# 1984 - 1990 Corvette: Service Bulletin: Power Seat Inoperative and/or Blows Fuses

**Subject:** POWER SEAT INOP/BLOWS FUSES REPAIR/REPLACE HARNESS

**Model and Year:** 1984-90 CORVETTE

**Bulletin Number:** 90-412-10 - (03/18/1991)

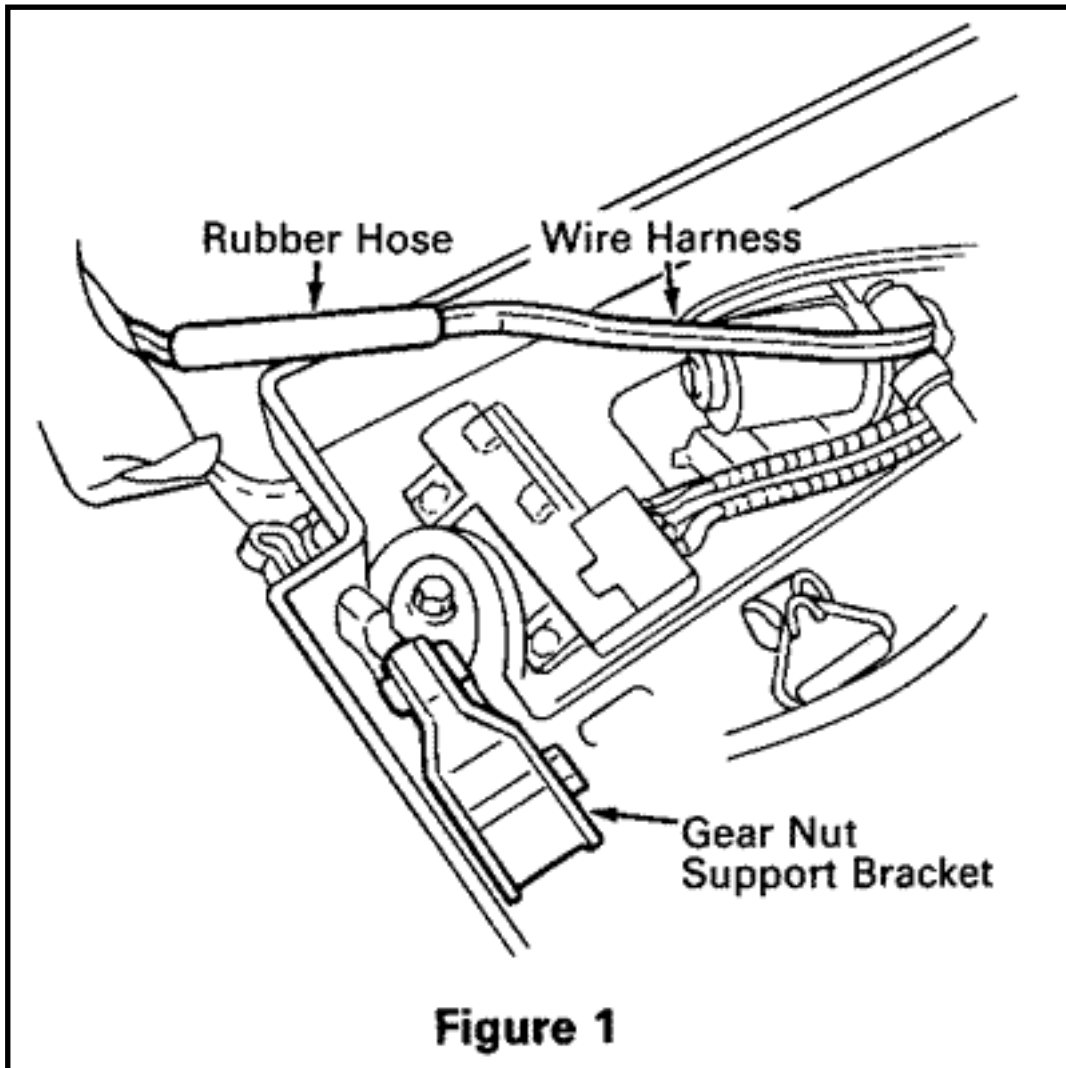
Power Seat (AQ9) inoperative and/or blows fuse.

Seat Control Switch Wire Harness may be shorted at gearnut support bracket. (See Illustration) With seat cushion installed, harness contacts gearnut support bracket and may become shorted with weight of driver/passenger.

Repair and/or replace harness as required. Using a section of rubber hose (gas line) about (4) inches long (split), cover harness as illustrated taping both ends.
